Access Compliance Report

Public Rights-of-Way

(Curb Ramps)

Intersection ID: 47614	Main Street: WYALONG_DR	Cross Street: MACQUARIE_LN	Location: NW
ADA ID: 2B20EED16C24	Ramp Type: BlendTrans1	Initial Pass/Fail: Fail	Overall Compliance: No
Severity Score: 10			
Codes/Mitigation Info/Possible Solution		Field Measurements/Component Compliance

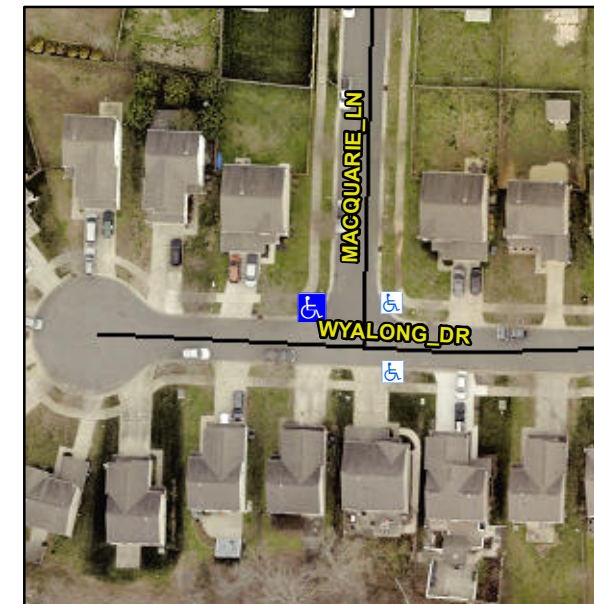
Not Found, R304.5.1, R304.5.3

Compliance	Description	Data	Compliance	Description	Data
N/A	Ramp Length (in)	72.0	Yes	BlendTrans Slope (%)	3.8
No	Ramp Width (in)	46.5	No	BlendTrans XSlope (%)	3.5
N/A	Flare Type LT	N/A	N/A	Flare Type RT	N/A
N/A	Flare Slope LT (%)	N/A	N/A	Flare Slope RT (%)	N/A
N/A	Flare Traversable LT?	N/A	N/A	Flare Traversable RT?	N/A
N/A	Landing Length (in)	N/A	N/A	DWS Provided?	N/A
N/A	Landing Width (in)	N/A	N/A	DWS Contrast?	N/A
N/A	Landing Slope (%)	N/A	N/A	DWS Length (in)	N/A
N/A	Landing X Slope (%)	N/A	N/A	DWS Full Width?	N/A
N/A	Landing Curb? (Y/N)	N/A	N/A	DWS Offset (in)	N/A
N/A	Shared Landing?	N/A			
N/A	Gutter Ponding?	N/A	N/A	Gutter Slope (%)	N/A
N/A	Gutter Lip Ht (in)	N/A	N/A	Gutter X Slope (%)	N/A
N/A	Painted X Walk1?	No	N/A	Painted X Walk2?	No
	X Walk 1 Direction	To S		X Walk 2 Direction	To E
	X Walk 1 Width (in)	N/A		X Walk 2 Width (in)	N/A
	X Walk 1 Slope (%)	2.4		X Walk 2 Slope (%)	5.2
	X Walk 1 X Slope (%)	3.5		X Walk 2 X Slope (%)	1.7

N/A	Ramp inside XWalk1?	N/A	N/A	Ramp inside XWalk2?	N/A
	Road Slope (%)	2.8		Clear Space?	N/A
	Road X Slope (%)	4.9	N/A	Clear Space to XWalk (in)	N/A
N/A	Any Obstructions?	N/A	N/A	Storm Grate/Utility Hazard?	N/A
	Obstruction Type			Storm Grate/Utility Type	
		N/A			N/A
			Yes	Surface Condition? (G/P)	Good
			No	Curb Slope (%)	20.4

Remove & Replace Curb Ramp With Two New Directional Ramps or Equivalent.
